**Title:** Crowned Ridge Wind II Sound Testing November 2022  
Data Review and Assessment

**Project:** Crowned Ridge Wind II, Docket EL19-027

**Prepared For:** South Dakota Public Utilities Commission

**Prepared By:** David M. Hessler, P.E., INCE

Figure 2.2.10

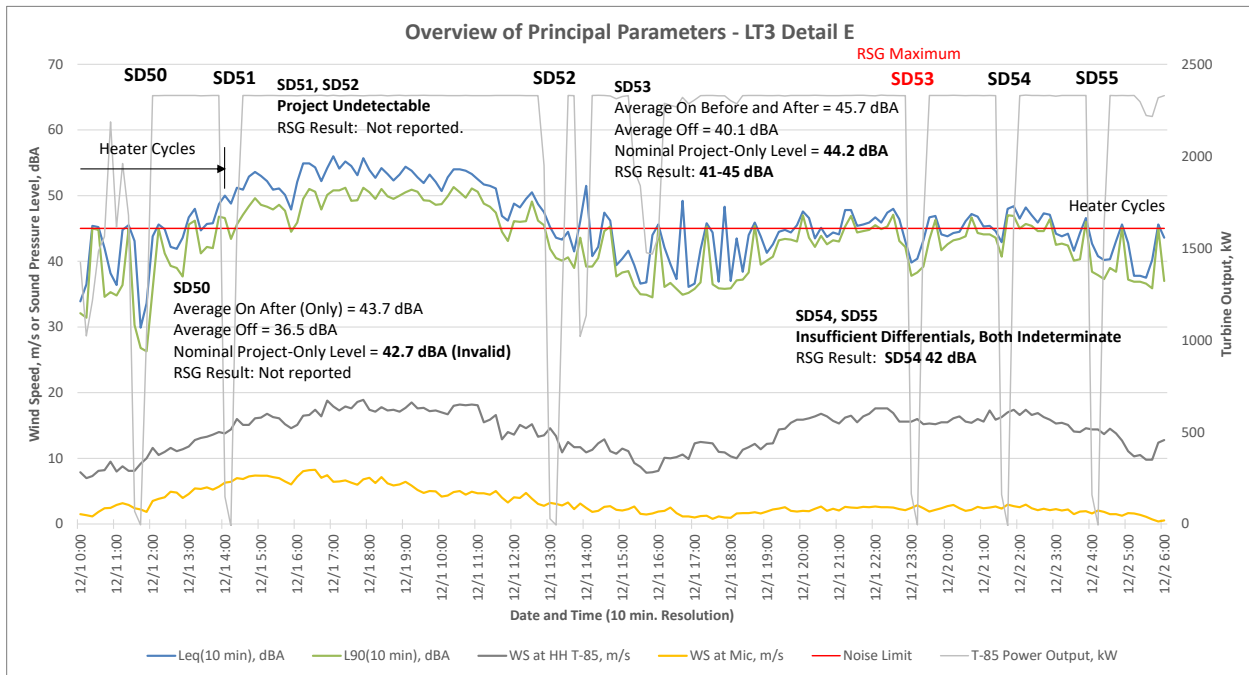
The first shutdown during this period (SD50) seems to have lined up perfectly with the nadir of a heater cycle oscillation. While it's possible to calculate a project-only level of about 43 dBA, all the data up to about 4:00 a.m. is clearly influenced by the heater and invalid.

Shutdown 53 is important because it is the outage used to derive RSG's maximum, survey high sound level for LT3 of 45 dBA. The detailed derivation, based on the 1/3 octave bands apparently containing wind turbine noise, is shown on pp. 52 - 53 of the report. We calculate a project-only level of 44.2 dBA just based on the A-weighted averages. The more sophisticated RSG derivation represents the conservative maximum possible Project level, and we would agree with their conclusion that the Project sound level is about 44 or 45 dBA at this location at this time. There is also a wide discrepancy between the wind speed at ground level and hub height, which suggests a strong wind speed gradient, or shear. These conditions can lead to amplitude modulation, or a thumping sound, as the wind contacts the rotor sweep with a greater velocity at the top than at the bottom. This phenomenon makes turbine noise more noticeable and potentially disturbing.

The next two shutdowns (SD54 and 55), only 2 and 4 hours later, don't show any correlation to the Project. The sound levels during these outages appear to reflect only background noise. Using the highest high after the shutdown and lowest low when the turbines were off, RSG was able to estimate a level of 42 dBA for SD54, but it's unclear whether these measurements have much of anything to do with the Project. In fact, the regular heater oscillation begins to return around the time of Shutdown 55.

Figure 2.3.4

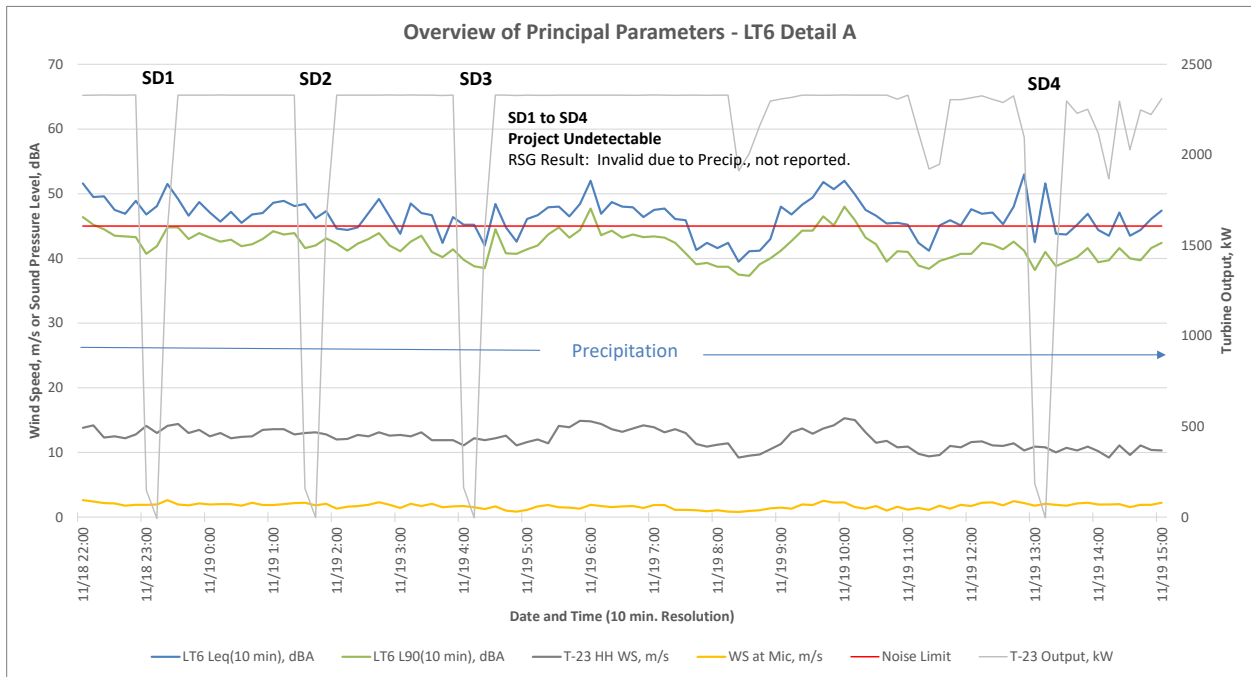
This detail during the first few shutdowns is largely identical to similar plots from positions LT2 and LT3. In all three cases, any noise from the Project was drowned out by rain or wind-induced background sound.

Figure 2.3.5

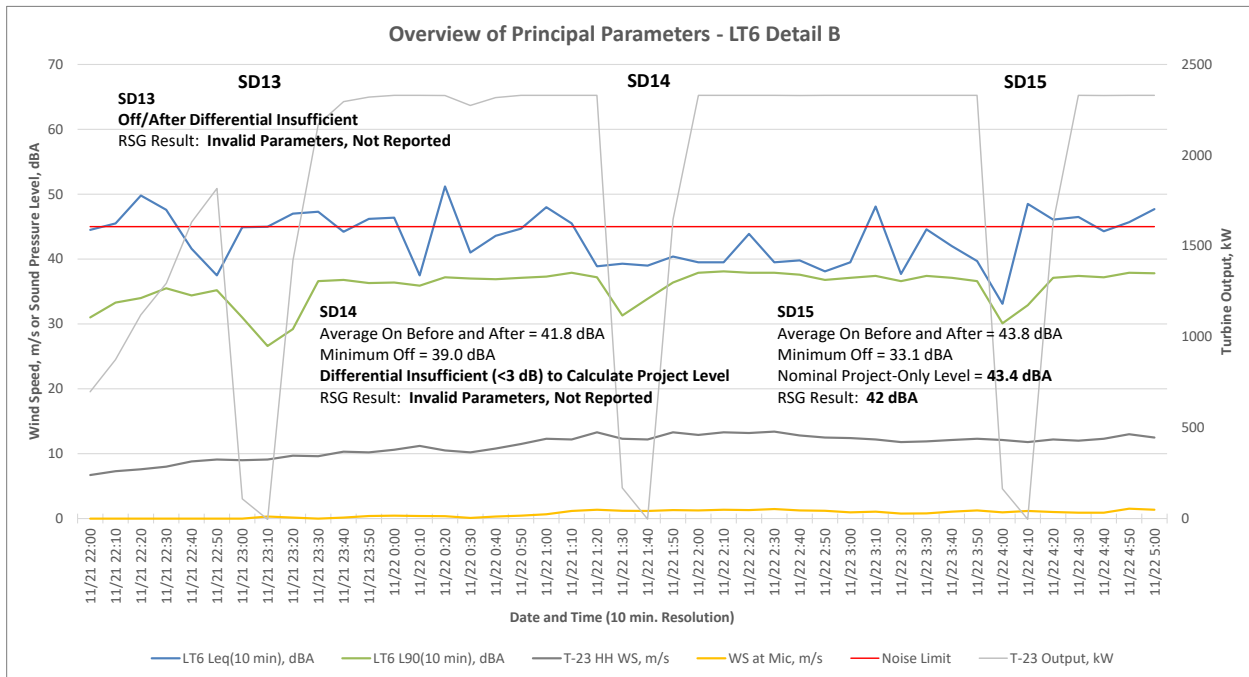
In this case, the residual sound level (L90) correlates fairly well with the shutdowns but the average (Leq) is very choppy, which means that sporadic background noises were occurring that prevented the average level from dropping smoothly in tandem with the elimination of turbine noise. If the noise spike in the middle of SD15 is ignored as interference, a project-only level of 43 dBA can be deduced from the data, although that number is almost certainly elevated by contaminating noise and should be considered conservative. RSG is reporting a sound level of 42 dBA for SD15.

Figure 2.3.6

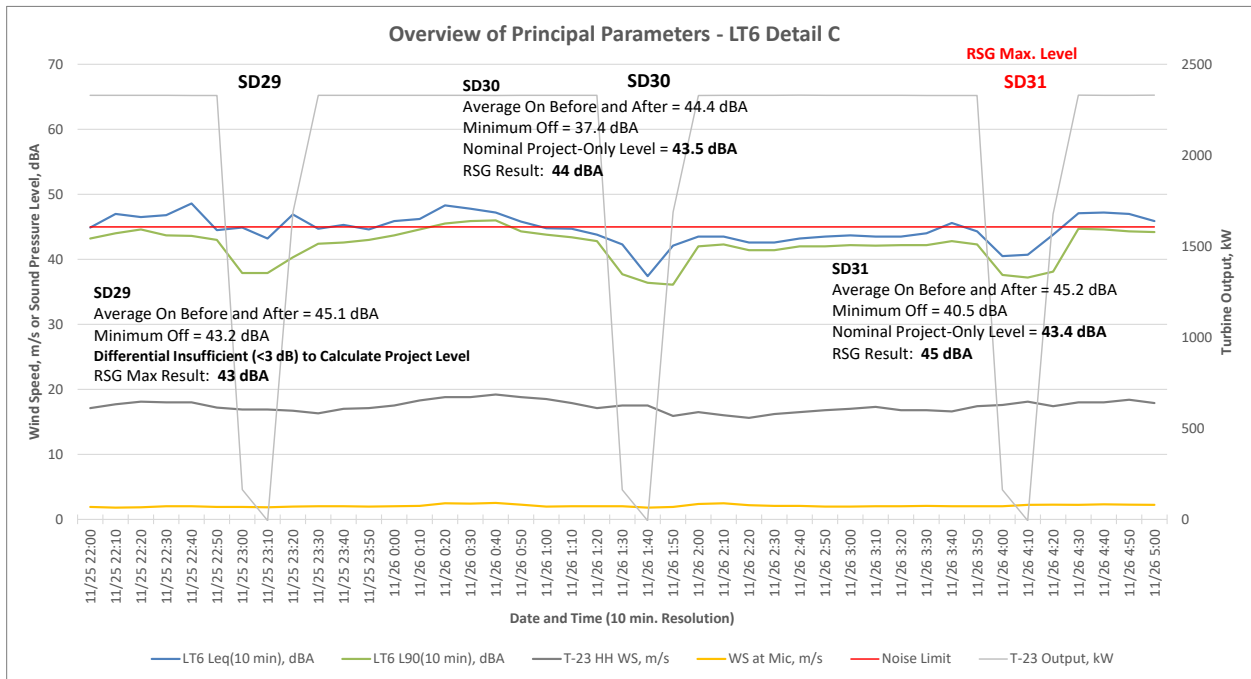
If the average Leq levels during the hour before and after SD29 are used as the project-on level then there is an insufficient on/off differential to compute a Project sound level. Using the highest high and lowest low RSG has derived a Project sound level of 43 dBA. Similar results were obtained from each method for SD30; essentially 43 dBA using the A-weighted averages and 44 dBA based on an analysis of individual measurements and their frequency content.

RSG has derived a maximum, survey high level of 44.9 dBA for LT6 from Shutdown 31, as detailed on pp. 56 and 57 of their report. This analysis uses the highest project-on levels just after the shutdown rather than the average hours before and after. Using this latter approach, we would estimate a level of 43 dBA for the Project.

Figure 2.3.7

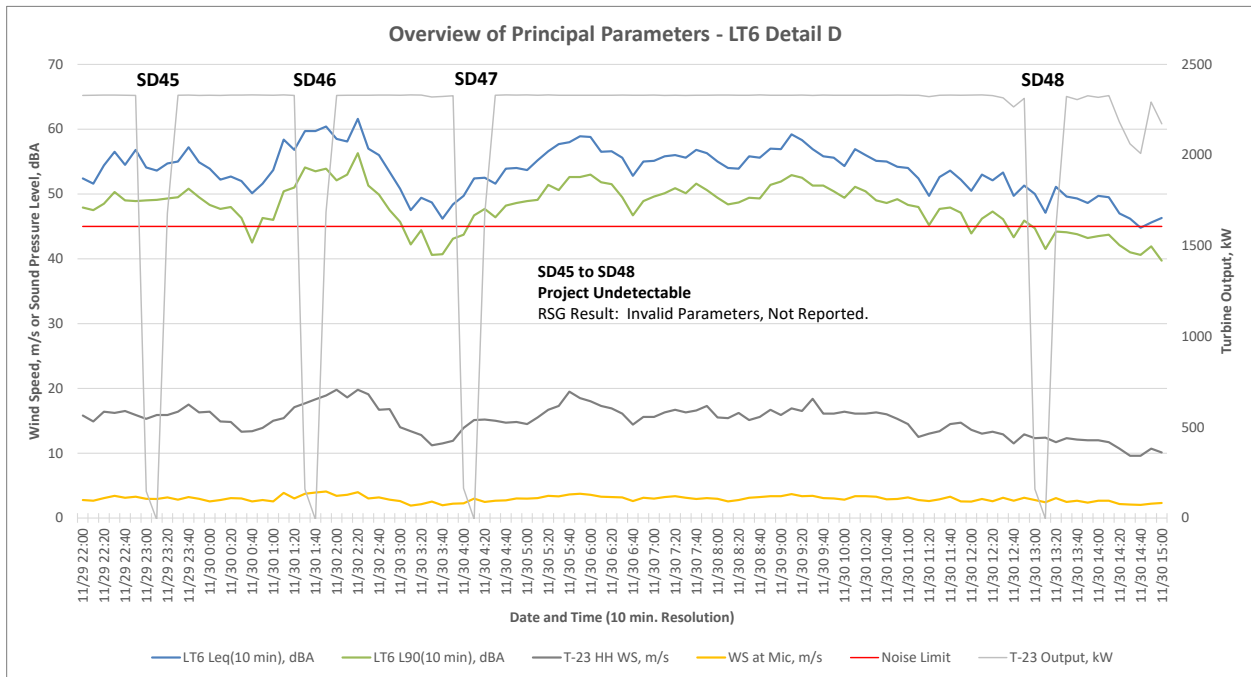
In this case, the overall sound level is dominated by wind-induced natural sounds because there is no obvious concurrent decline in the sound levels during any of the four shutdowns depicted here.

Figure 2.3.8

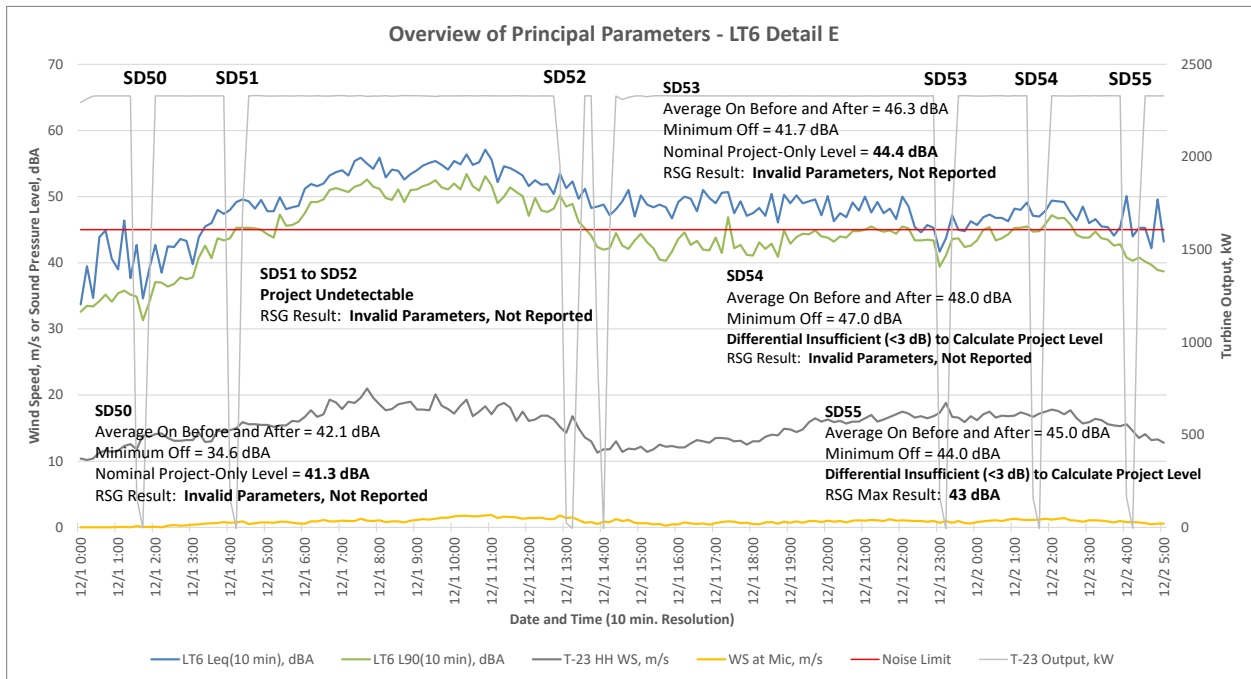
The dip in sound levels during SD50 allows a calculation of 41 dBA to be made for the Project. It is not known why RSG did not calculate project levels for most of the shutdowns during this period – possibly some unseen parameter like temperature or humidity. The only other shutdown in this group that seems to have moved the needle on the sound level is SD53. We estimate a project-only level of 44 dBA using the hourly averages before and after and the minimum level during the outage. This is the highest Project sound level we have observed for LT6.

Oddly, RSG is reporting a level of 43 dBA for SD55, which isn't a promising looking shutdown at all in terms of the behavior of the sound levels. Some contaminating noise event apparently happened right when the turbines shut down. That impediment notwithstanding, the report indicates that the project-on Leq level 30 minutes before the shutdown of 46 dBA was used as the on level and 42 dBA for the off level. The lowest level during this outage was 44 dBA, at least in terms of 10 minute integrations. Their off value may have come from a 1 second reading, but it's not clear.

Figure 2.3.9

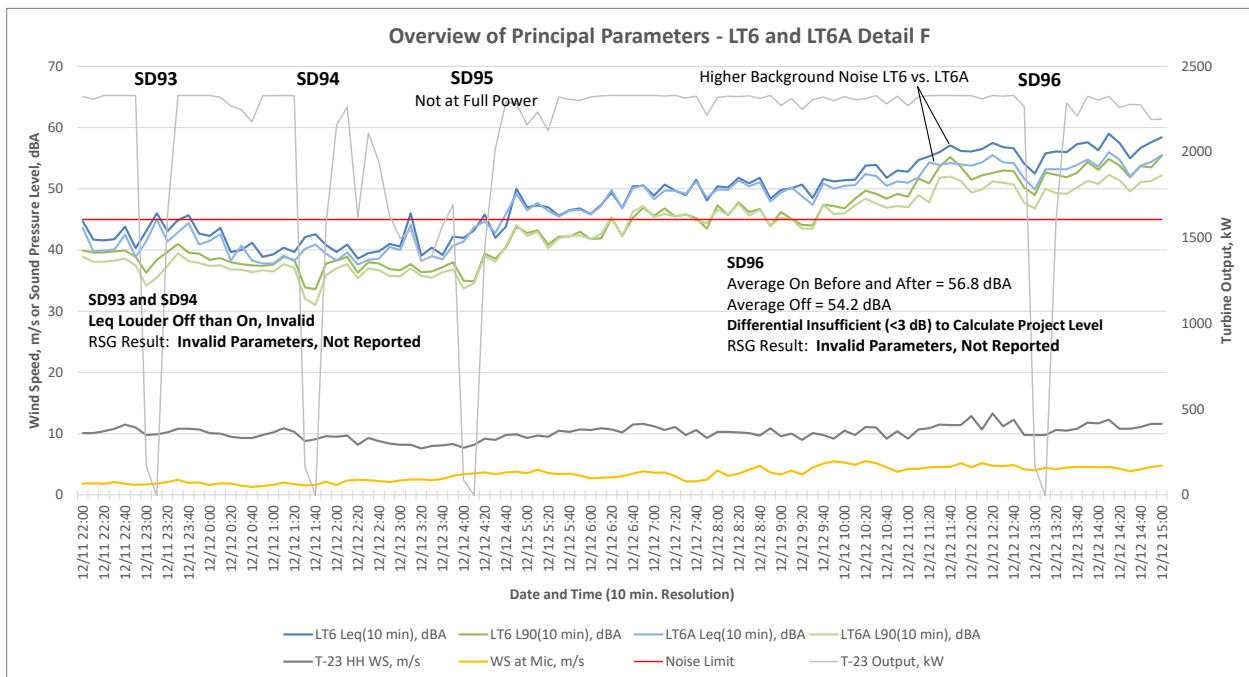
None of the on/off Leq differentials during this period allowed for a valid calculation of the Project sound level. Around the time of SD96 the sound levels at two positions diverge suggesting that background noise at the alternative location was somewhat lower during that time. Although the average windspeeds were fairly constant during this period, wind gusts may have become more frequent and prominent.
